**Development of Draft Construction Safety
Standards for Excavations. Volume 2**

Development of Draft Construction Safety Standards for Excavations

An NBS/NIOSH Publication Volume II

April 1983

✓ Figure 1. Effects of Nearby Foundation Loads That Must be Determined by an Engineer

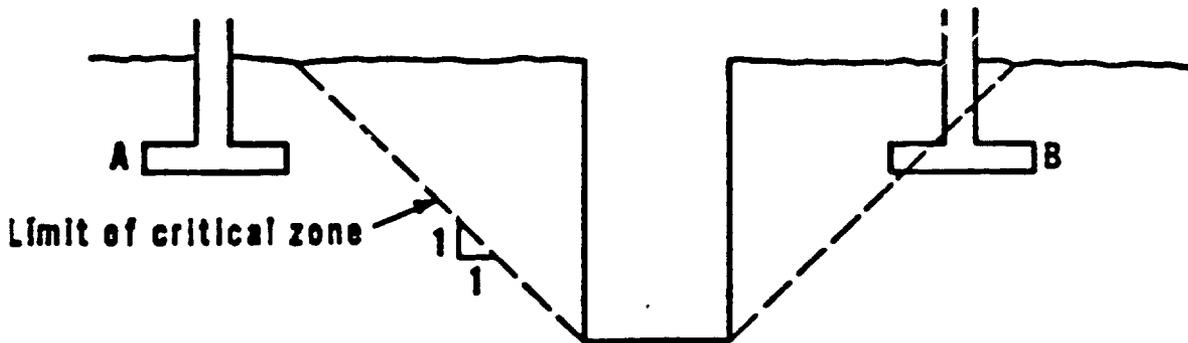
- ✓ a. If there is a deviation from the provisions of the Standard Practice, shoring, shielding or sloping requirements must be determined by an engineer (a qualified person ?) *or other experience qualified person.*
- ✓ b. An engineer shall determine the shoring, shielding or sloping requirements whenever the bottom of a building foundation adjacent to the excavation which has not been secured by underpinning extends into the critical zone delineated in Figure 1.

Figure 4. Components of the Shoring System

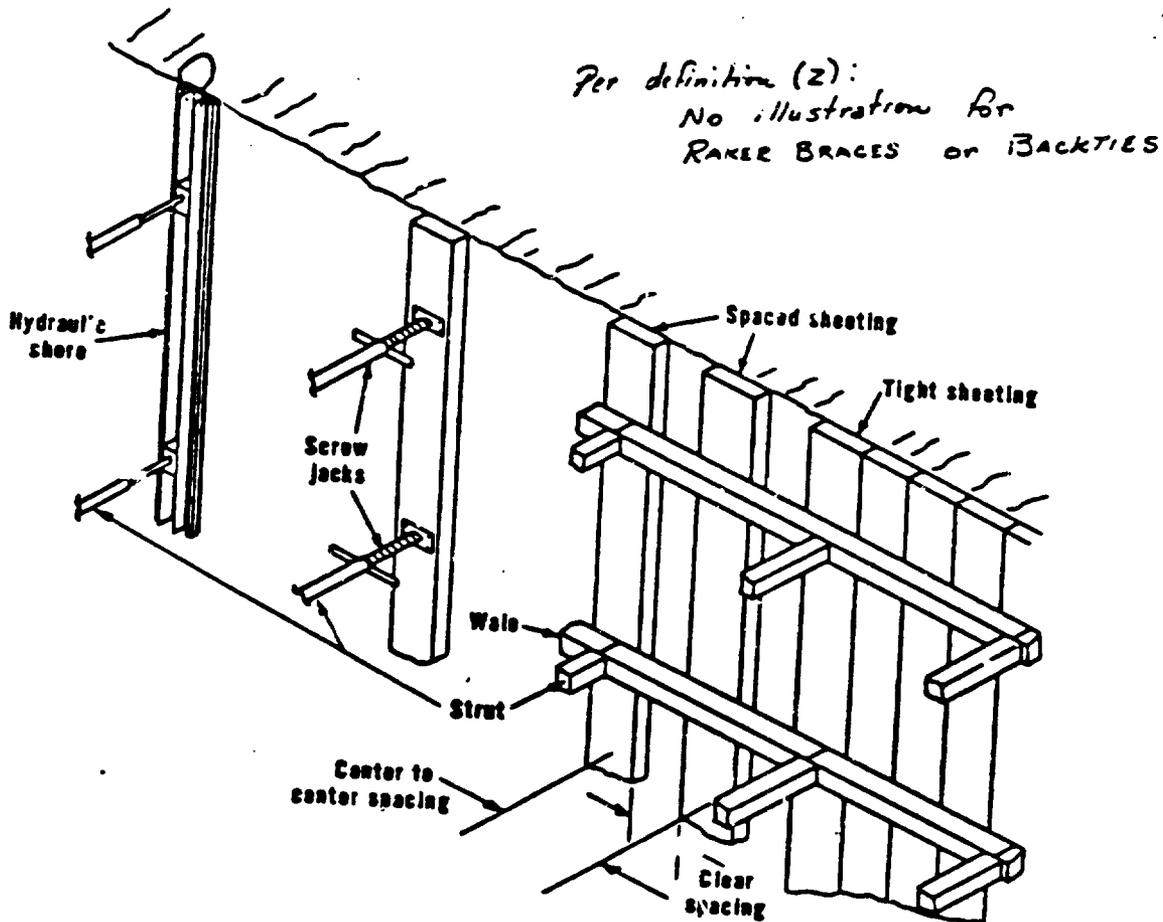
- ✓ (w) Spaced Sheeting is sheeting in which the members bearing against the excavation wall are spaced (see Figure 6). *Figure 4?*
- ✓ (x) Spalling is the continuous flaking and falling of soil or rock from an unsupported trench wall.

- ✓ (y) Standard Practice is the trenching and shoring practice in Section 1926.652 (b).
- ✓ (z) Struts are the primary support members of a shoring system including but not limited to cross braces, raker braces, jacks and backties (see Figure 6) *Figure 4?*

Raker braces or backties are not illustrated
